DOCKET ITEM #9

Master Plan Amendment #2020-00001

Development Special Use Permit #2020-00003

Potomac Yard Landbay H West - Silverstone

Graphic A: Height-to-Setback Ratio Modification Exhibit

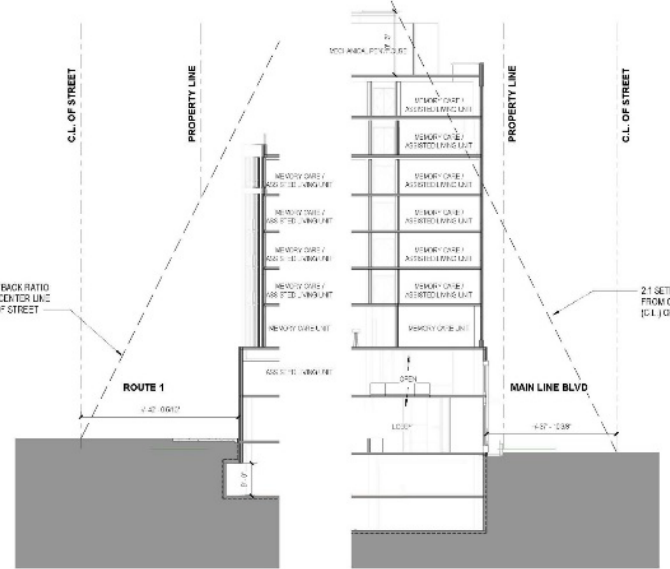
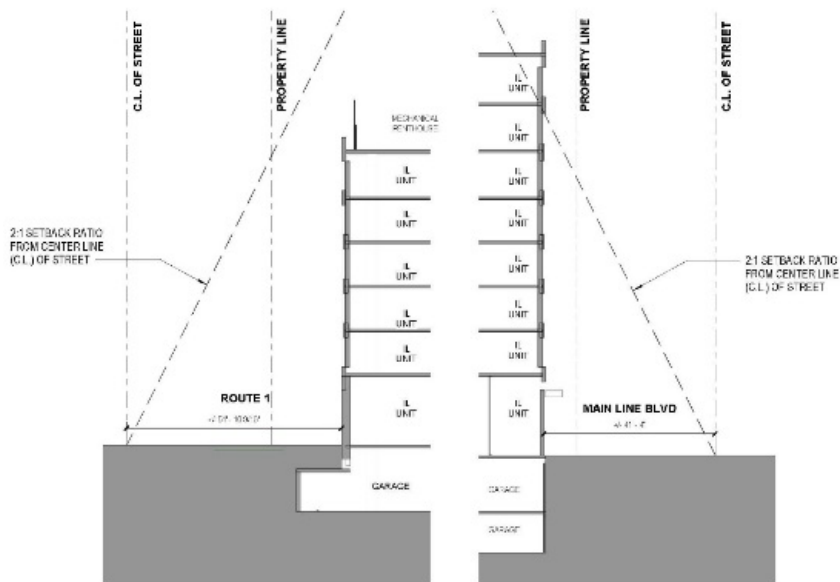
The height-to-setback requirement modification is requested in two instances for Building 1 (along Swann Avenue and Main Line Boulevard) and two instances for Building 2 (along Main Line Boulevard and Maskell Street). For Building 1, it represents about 16.5 feet of additional height compared to the setback provided along Swann Avenue and about 16.7 feet along Main Line Boulevard (or about 8.25 feet and 8.35 feet, respectively, of reduced setbacks compared to the heights provided).

For Building 2, it represents 13.2 feet of additional height compared to setback provided along Main Line Boulevard and 11.5 feet of additional height along Maskell Street (or about 6.6 feet and 5.75 feet, respectively, of reduced setbacks compared to the height provided). These types of modification are a result of the meandering nature and variable width of Main Line Boulevard coupled with the approved building heights per the Small Area Plan. The Small Area Plan anticipated taller buildings in this portion of Potomac Yard as blocks approached the Town Center in Landbay G and Landbay F (North Potomac Yard). Staff believes the modifications are desirable given that the proposed buildings are appropriately setback while supporting the continued streetwall consistent with the urban development pattern broadly recommended in the Small Area Plan and the Urban Design Guidelines and Standards.

The buildings have been designed in such a way that break down the form of the buildings using variable heights, building stepdown, and architectural detail. The buildings comply with the streetscape standards per the Potomac Yard Design Guidelines as well as heights as proposed by the Small Area Plan. The adjacent vacant parcel in Landbay H is planned for office use with a maximum height of 110 feet and would be consistent with the heights proposed along Main Line Boulevard. Also, the ground-level open space and landscaping create a pleasant pedestrian environment that mitigate the requested height.

Given the nature of the height-to-setback modification requests, and that they have been mitigated as mentioned previously, staff believes that their approval would not be detrimental to neighboring property or to the public health, safety, or welfare.

Graphic F: Building #1 – Revised SW Elevation per PYDAC Comments 10.5.2018

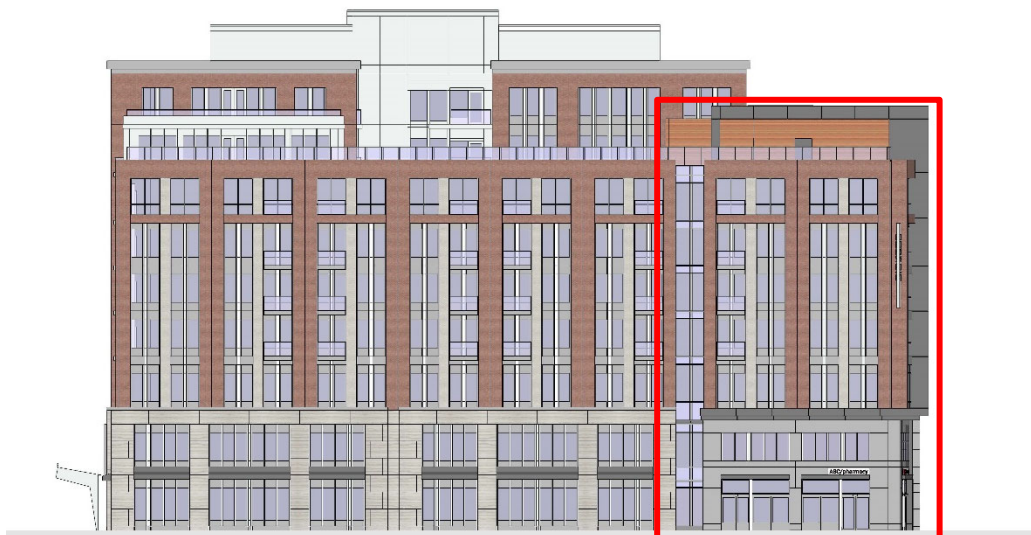
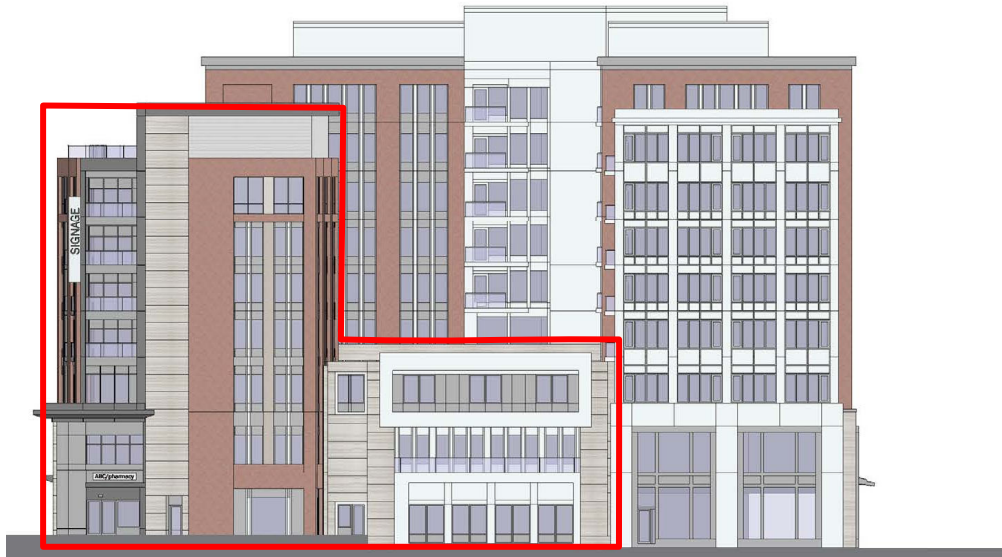
Graphic E: Building #1 – Originally Proposed SW Elevation
